**NZ 198/05 AUSTRALIA – Queensland – Coral Sea – Diane Banks – Depths.**

UKHO Notice 3473/05  
 NI 178/2005

**Chart NZ 14602 (INT 602) [ 179/05 ]**

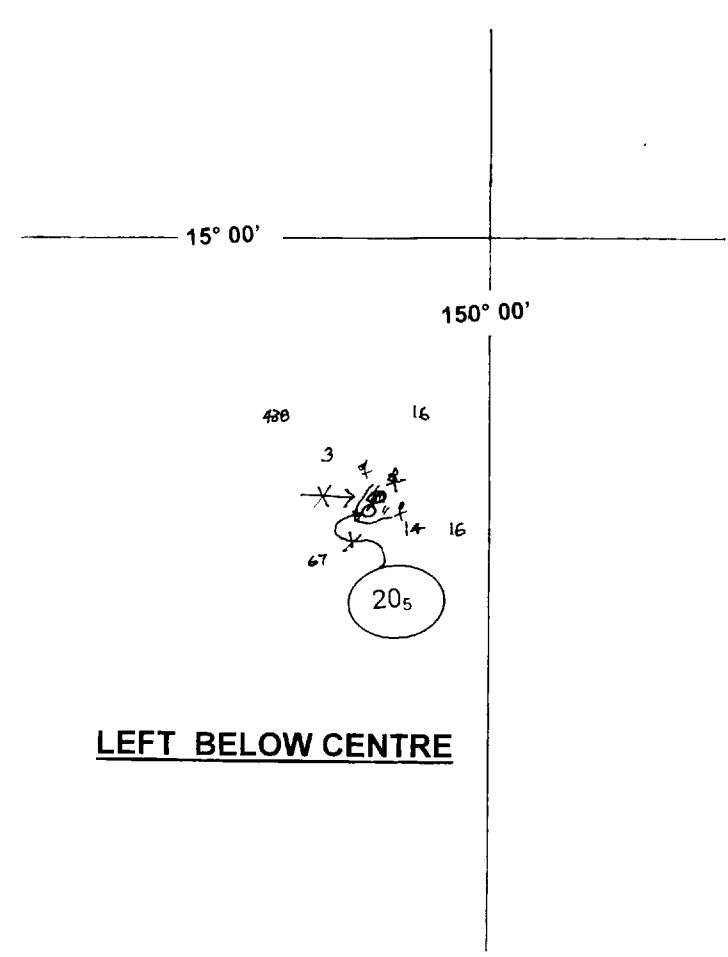
Insert depth 20<sub>5</sub> and extend 30m contour to enclose (a) 16° 09'.0S., 149° 29'.5E.  
 Delete depth 31 close to (a)

**Chart NZ 14604 (INT 604) [ 180/05 ]**

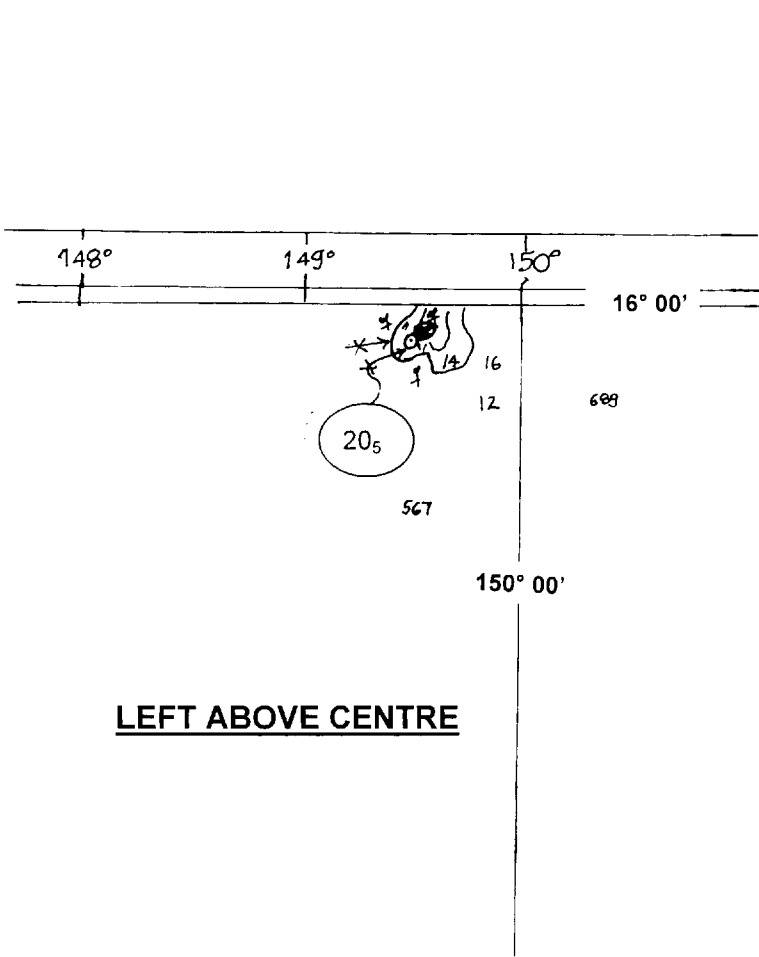
Insert depth 20<sub>5</sub> and extend 30m contour to enclose (b) 16° 09'.0S., 149° 29'.5E.  
 Delete depth 31 close to (b)
